SRF No. 9114

SUBJECT: KENWOOD ARROWHEAD SIGNAL AND ROADWAY IMPROVEMENTS
PROPOSED AMENDMENT #1
ADDITIONAL ROADWAY DESIGN AND RELATED TASKS

Project Name **Arrowhead/Kenwood Signal and Roadway Improvements
Amendment #1**

Figure 1D

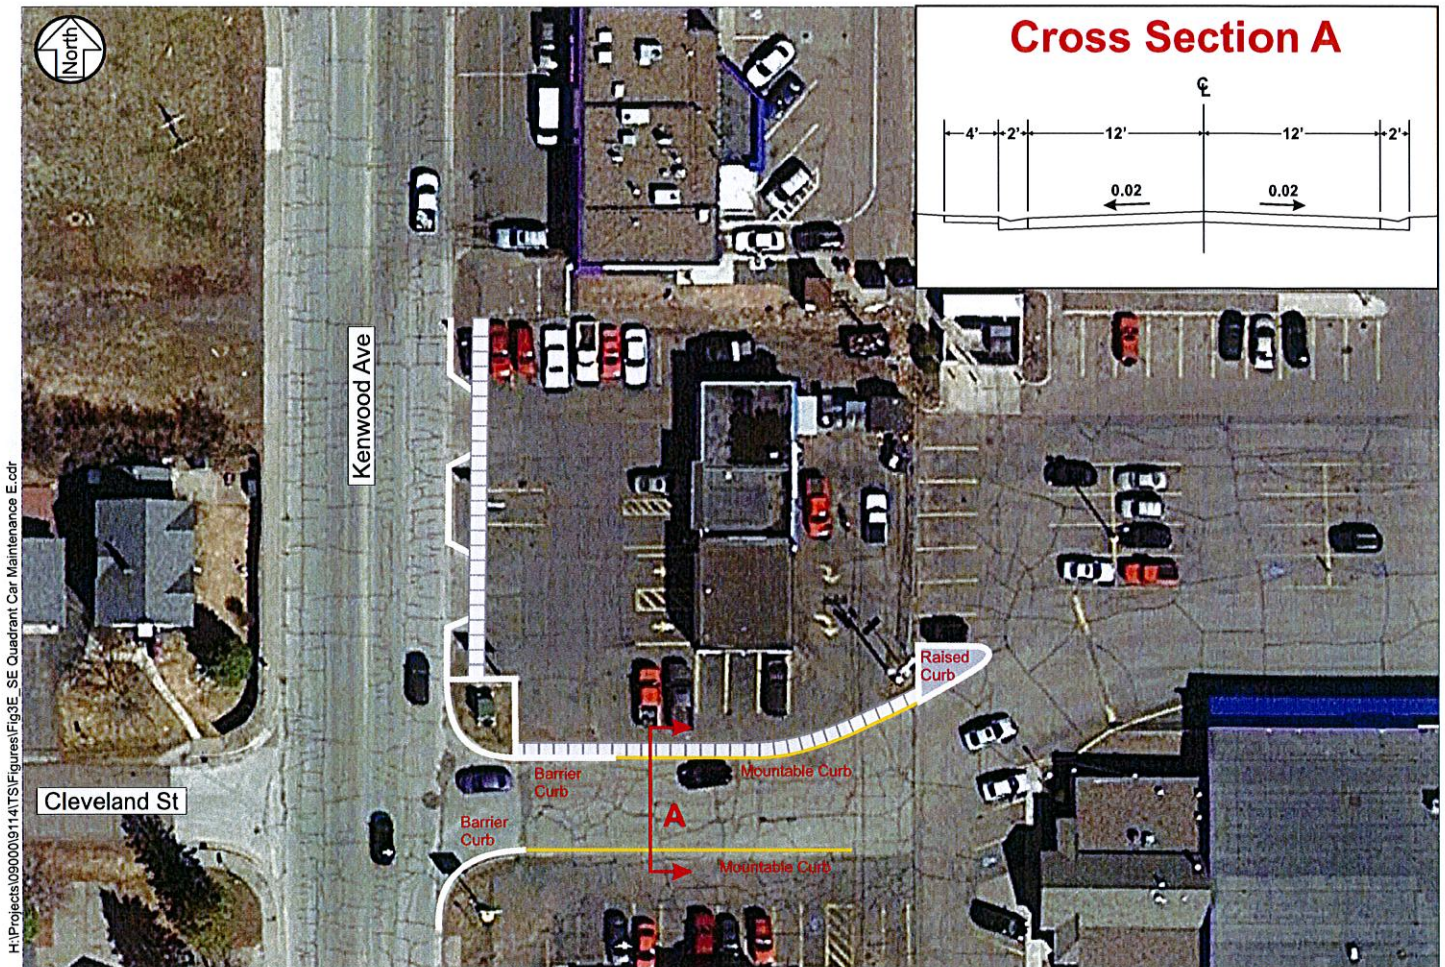
2. Preliminary and Final roadway design plans, specifications and engineer's estimate for a shared access for US Bank/Wells Fargo in the northeast corner of the Kenwood / Arrowhead intersection. The scope of this work is as generally shown in Attachment B. The new shared access will be a driveway off Warren Avenue. The design will include closure of two driveways on Arrowhead Road. The west entrance to Wells Fargo will be relocated as far north as is practical. The design will incorporate modifications to existing storm ponds that serve the US Bank site. Design of the pond modifications will comply with the City of Duluth Uniform Development Code storm water requirements associated with a redevelopment project.
